DEPARTMENT OF BIODIVERSITY, CONSERVATION AND ATTRACTIONS REPORT

PROPOSAL	The installation of lighting and luminaires at Charles Court Reserve
LOCATION	Lots 0 on Plan 4480 and 792 on Plan 2948, and 5168 on Plan 91504 (R22527) Charles Court Reserve, Nedlands
COST	\$1,300,000
APPLICANT	City of Nedlands
LANDOWNER	City of Nedlands
LOCAL GOVERNMENT	City of Nedlands
MRS CLASSIFICATION	Regional Open Space
DECISION TYPE	Part 5, <i>Swan and Canning Rivers Management Act 2006</i> , Ministerial Determination
ATTACHMENTS	<p>1A Lighting layout</p> <p>1B Rugby WA letter of support</p> <p>1C External referral responses:</p> <ul style="list-style-type: none"> • City of Perth • City of Nedlands <p>1D Section 74 – Summary of public submissions</p> <p>1E Section 75 – Summary of public submissions on Draft Report</p> <p>1F Section 75 – Referral response on Draft Report</p> <p>1G Site photos</p> <p>1H Light spill diagrams</p> <ul style="list-style-type: none"> • Original light spill diagrams (Sage Consulting Engineers) • Revised light spill diagrams (Sage Consulting Engineers)

RECOMMENDATION	APPROVAL WITH CONDITIONS

Figure 2: Charles Court Reserve – Location of the eight new poles (P1 to P8)

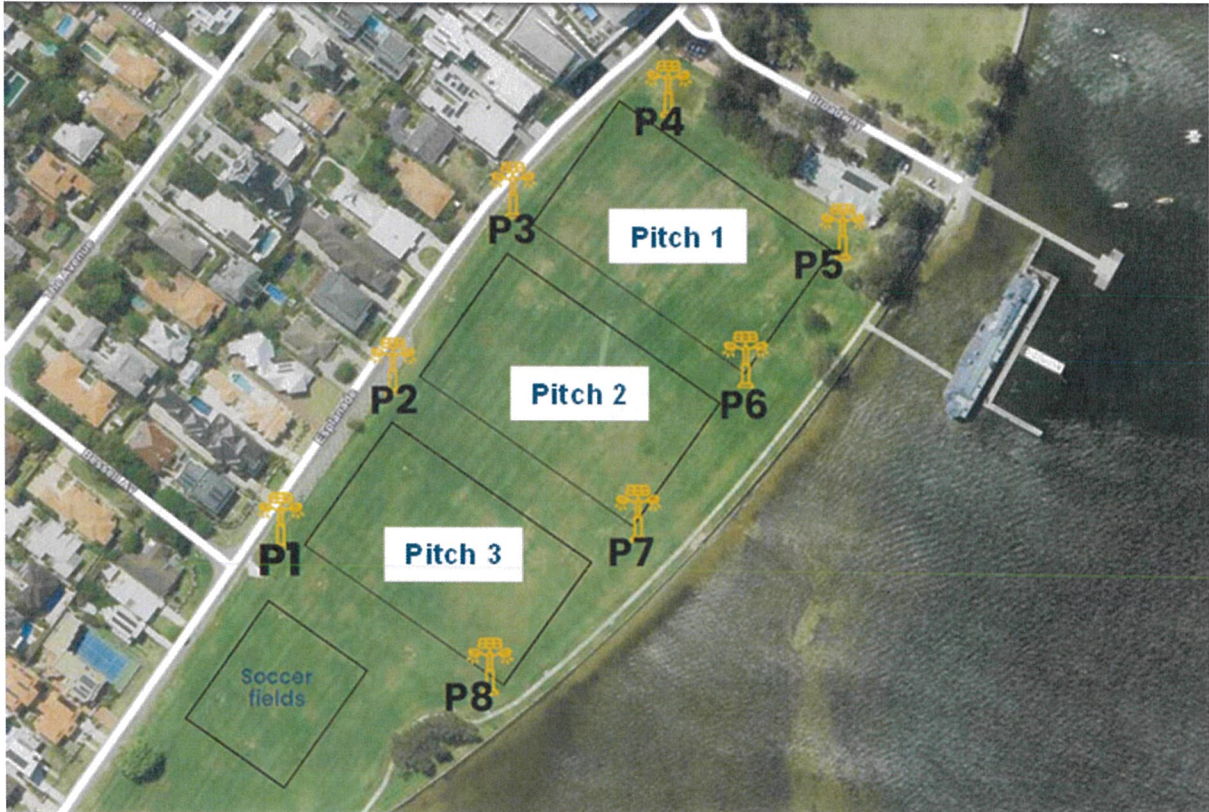
- Excessive height of six poles (30m and 33m), being above the height of neighbouring properties. The high poles will adversely affect aesthetics and property values.
- Poor positioning of one pole (**Figure 2 - P4**) in the north-east corner.

ELECTRICAL SERVICES
CITY OF NEDLANDS
CHARLES COURT RESERVE
SITE PLAN

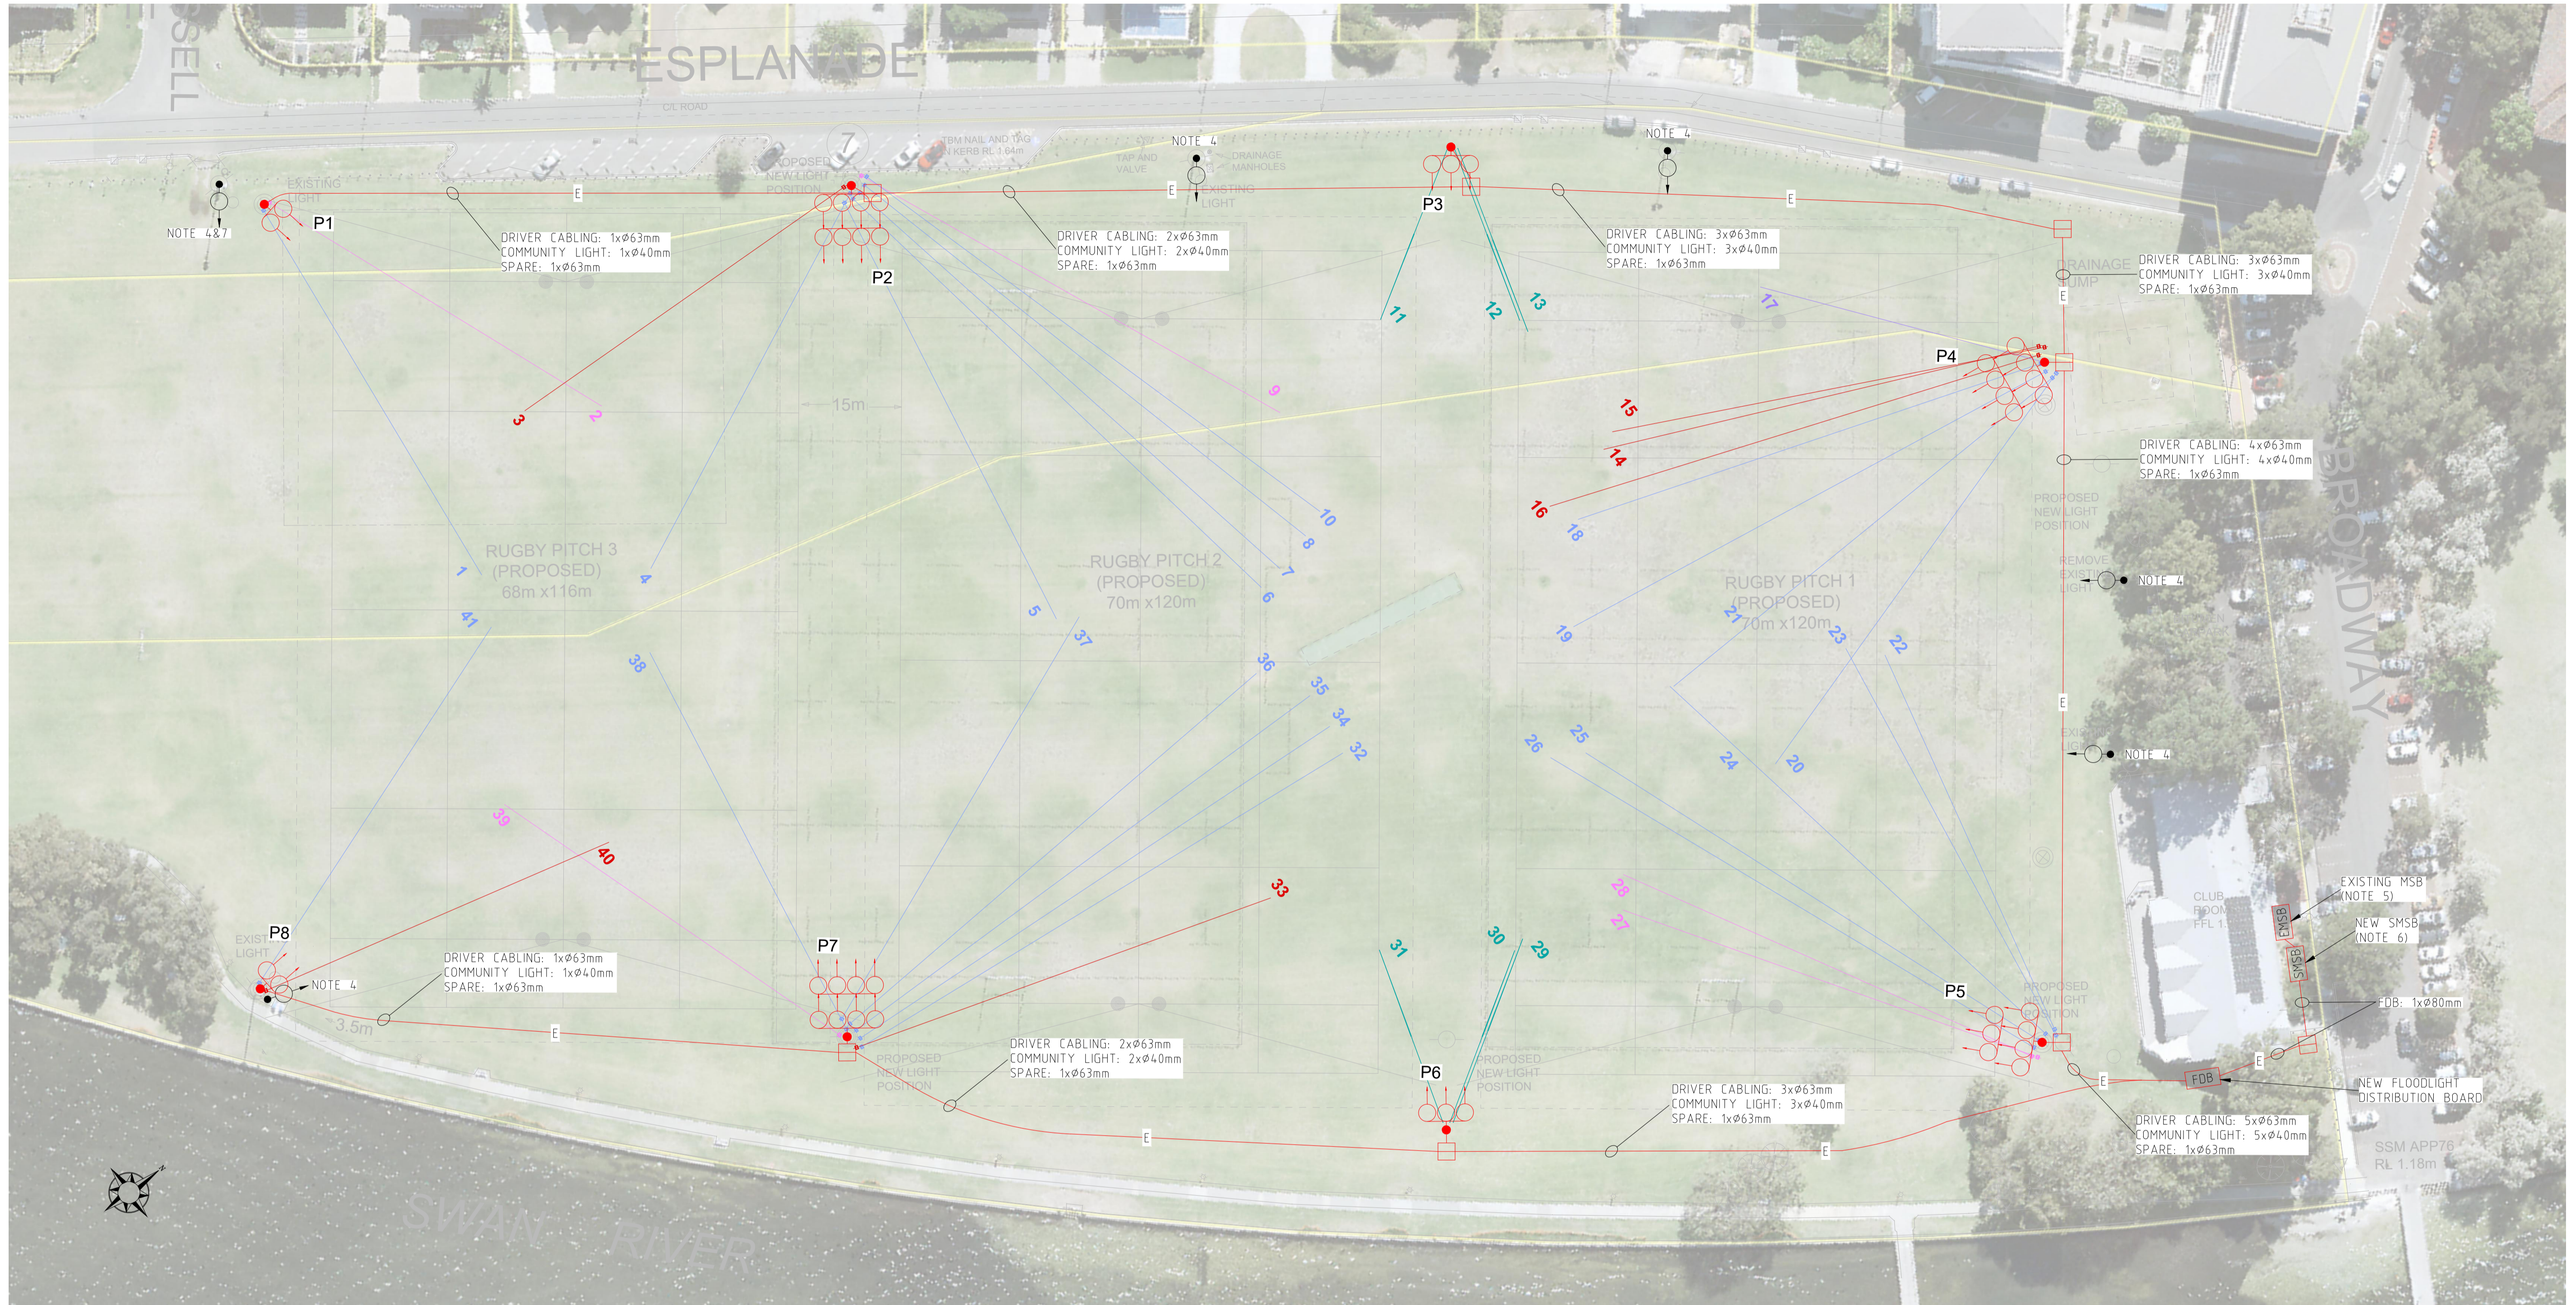
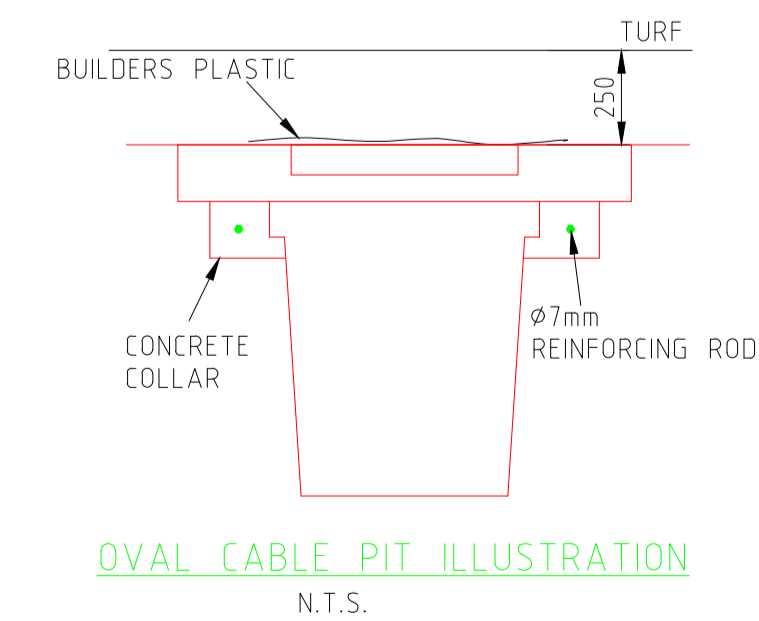
to concerns raised by DBCA, the cabling has been relocated further away from the river and riverwall (Drawing No. E1B).
